Iqaluit RCMP Building - Mechanical Snow Shed

The following revisions and clarifications to the tender documents are effective immediately. This addendum will form part of the contract documents.

END OF STRUCTURAL ADDENDUM #S1 (Addendum #1)

Drawing S100:

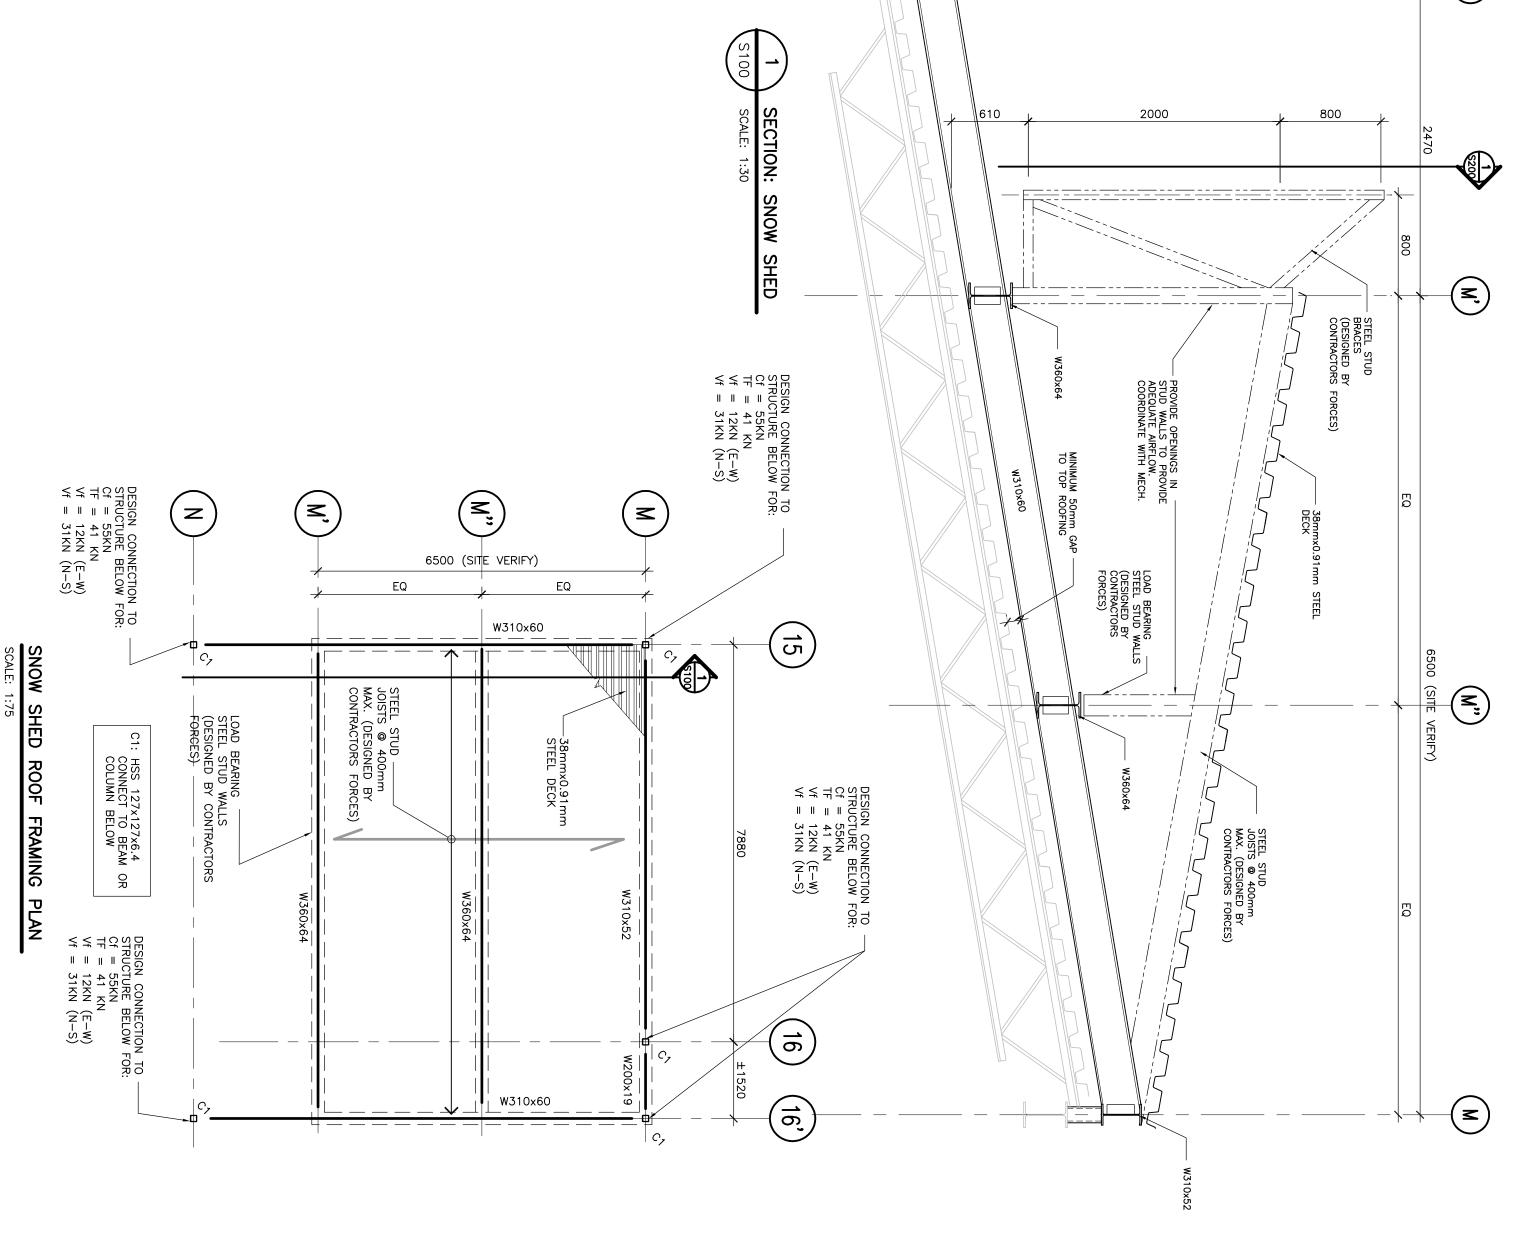
- 1. Notes have been updated to reference 2012 OBC & 2010 NBC.
- 2. Notes have been updated to clarify that shop drawings are to bear the stamp of an engineer licensed in the Territory of Nunavut.
- 3. Notes for steel deck fastening have been updated.
- 4. The snow shed framing shown in plan and section has been changed from all structural steel to steel studs bearing on steel beams. The steel stud framing is to be designed by the contractor's forces and stamped by a structural engineer licensed in the Territory of Nunavut.

Drawing S200:

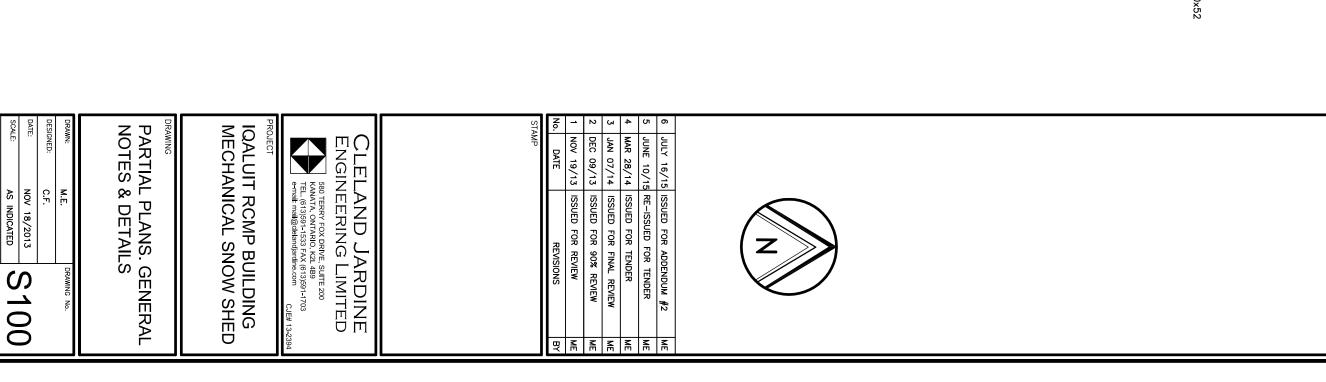
1. Section 1 and Section 3 from the original drawings have been deleted. Section 2 has been renamed Section 1 and has been modified to show the steel stud framing to be designed by the contractor's forces.
